**TSG-RAN Meeting #10
Bangkok, Thailand, 6 - 8 December 2000**

TSGRP#10(00)608

Title: Agreed CRs to TS 25.402

Source: TSG-RAN WG3

Figure 6: Usage of Synchronization Ports

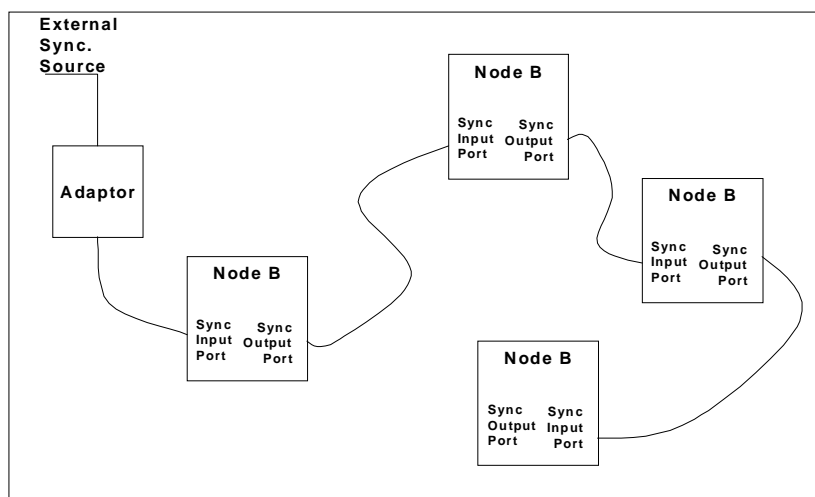
The input synchronization port (SYNC IN) allows the Node B to be synchronised to an external reference (e.g. GPS), while the output synchronization port (SYNC OUT) allows the Node B to synchronise directly another Node B (see Figure 6).

If a valid synchronization signal is detected, the Node B regenerates that signal at its output synchronization port. ~~The propagation delay between the input and output synchronization ports shall not exceed 500 ns.~~

Figure 7: Synchronization signal

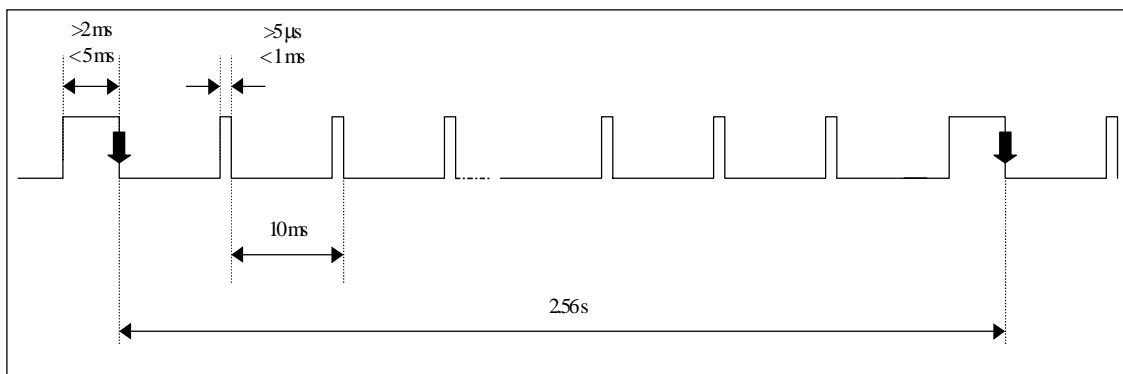
The synchronization signal (illustrated in Figure 7) is a 100 Hz signal having positive pulses of width between $5\ \mu\text{s}$ and $1\ \text{ms}$, except when $\text{SFN mod } 256 = 0$ (every 256th pulse), which has a pulse width between $2\ \text{ms}$ and $5\ \text{ms}$. This signal establishes the $10\ \text{ms}$ frame interval and the $2.56\ \text{s}$ multiframe interval. The start of all frames in the cell of the node B is defined by the falling edge of the pulse. The required accuracy for the phase difference between the start of the $10\ \text{ms}$ frame interval and the falling edge of the synchronisation pulses is defined in [15].

The start of the 256 frame period is defined by the falling edge of the pulse corresponding to the frames where $\text{SFN mod } 256 = 0$ (i.e. of width between $2\ \text{ms}$ and $5\ \text{ms}$).

The relative phase difference of the synchronization signals at the input port of ~~two neighbouring any~~ Node B's in the synchronised area shall not exceed ~~5~~ 2.5 μs .
